RE: Notice of Final Action – Emission Reduction Credits
Facility Number: S-511
Project Number: S-1123816

San Joaquin Valley Air Pollution Control District
ERC Application Review - Greenhouse Gases
Reduction in Gas Turbine Engine Use
Revised Final Decision

Facility Name: Sycamore Cogeneration Company

Project #: S-1123816

Oil Production Graph

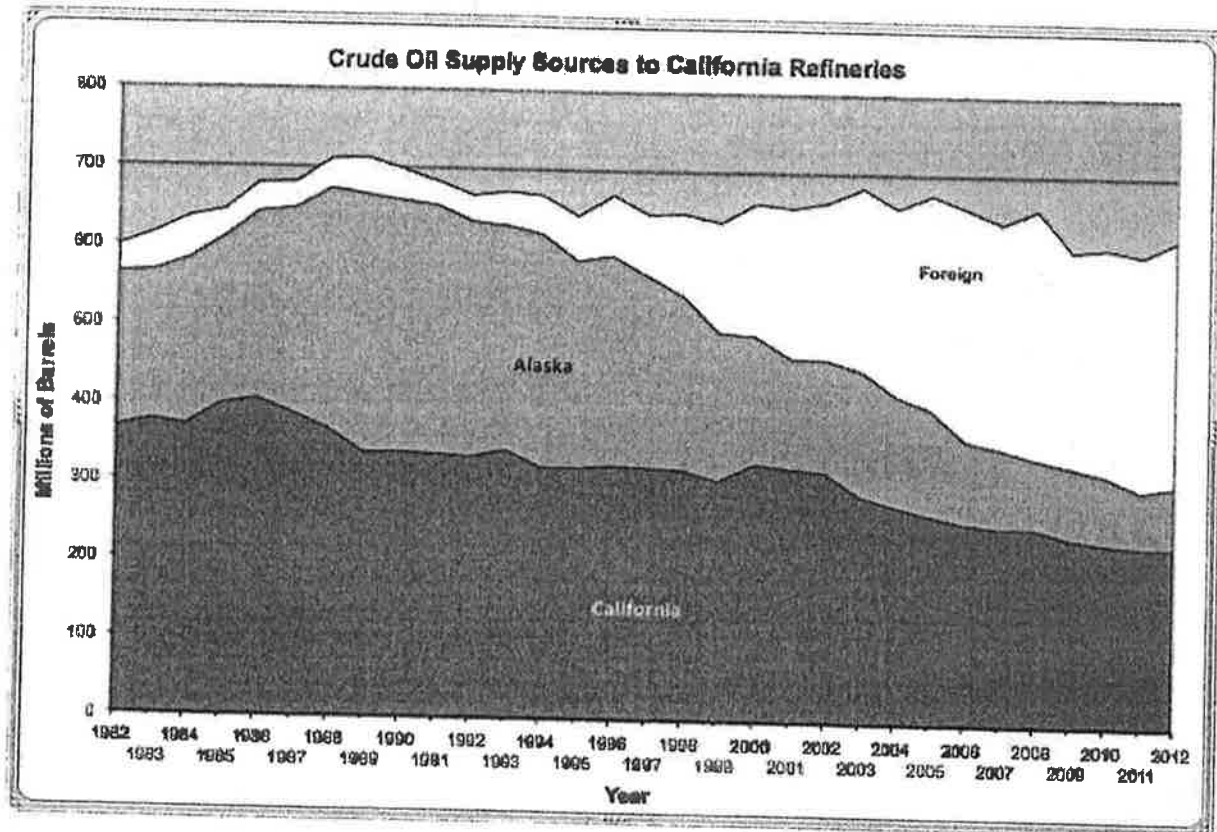
Several lines of evidence suggest that the future of oil production in California may buck historic trends. It is well-established that the oil market is highly volatile, making historic trends questionable predictors. More specifically, Kern County recently issued an environmental impact report ("EIR") for its ordinance creating a ministerial process for oil

Sycamore has selected California as the geographical boundary for which the emission reduction is permanent. Sycamore/Chevron has provided information verifying that the total oil production in the state of California has been in decline since 1985 (see graph in Appendix B). Additionally, Sycamore/Chevron is subject to the California Cap-and-Trade regulation which requires Chevron to reduce or mitigate a permanent reduction in GHG emissions. The combination of the decline in oil production in California and the reductions required by California's Cap-and-Trade regulation verify that the reductions are permanent within California. The geographical boundary for the ERCs will be the State of California and the ERC will include the following identifier:
